**RE: St Joseph on the Rio Grande Church
5901 St Joseph Dr NW
Grading and Drainage Plan
Engineer's Stamp Date: 8/10/18
Hydrology File: G11D014A**

Based on the submittal received on 8/10/18, the Grading and Drainage Plan cannot be approved for Building Permit until the following are corrected:

Re: G11D014A - Church of St. Joseph on the Rio Grande –Grading Plan for Building Permit

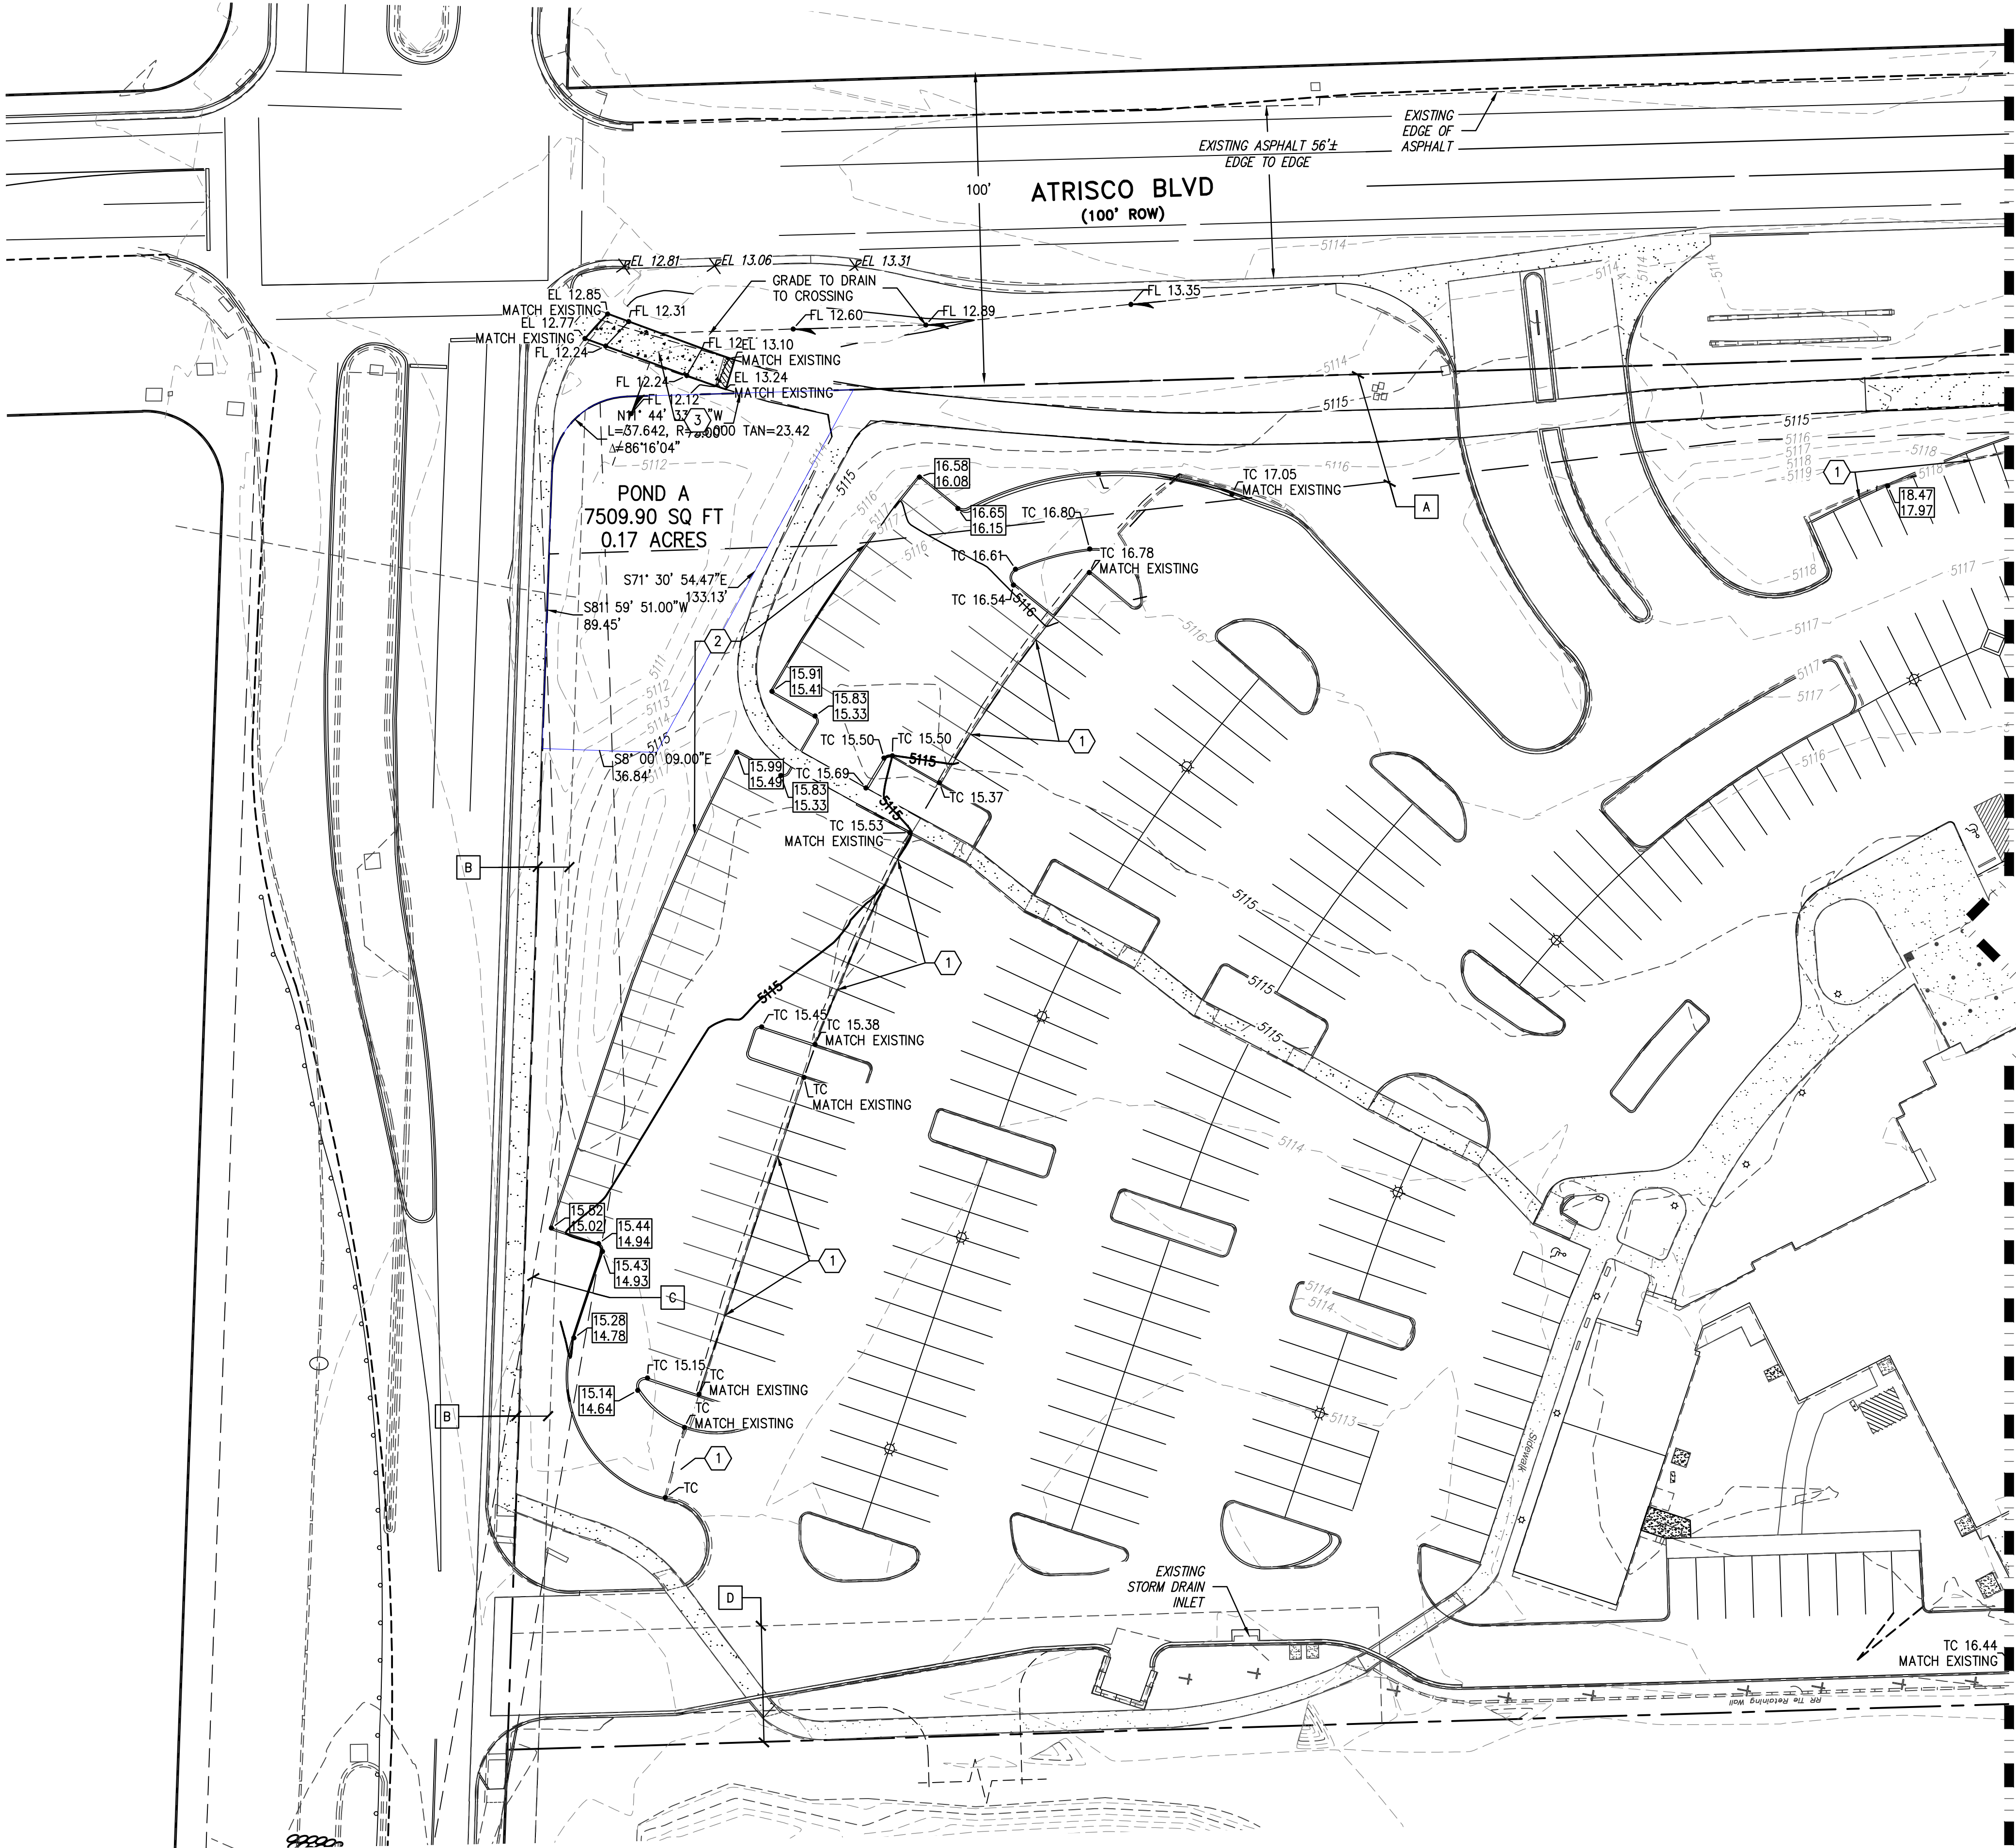
1. Remove all "Conceptual/Not for construction" markings.
2. The top of grate elevation is shown as 12.56' but the surrounding grades are ~11.9'; the grate should be in the low spot.

3. *Provide invert-out elevation for both outfalls into the private pond.*

4. *Provide an emergency spillways or 2x capacity for the private storm drain; this is applicable when the inlets are in a sump conditions. Provide supporting calculations for the chosen options..*

The inverts are indicated.

An emergency overflow is indicated on the plan. In addition, the entire face of the pond at the cul de sac can act as an overflow for the inlet. The weir capacity of the 11' opening is 12.49 cfs, and the inlet flow is 11.77 cfs.
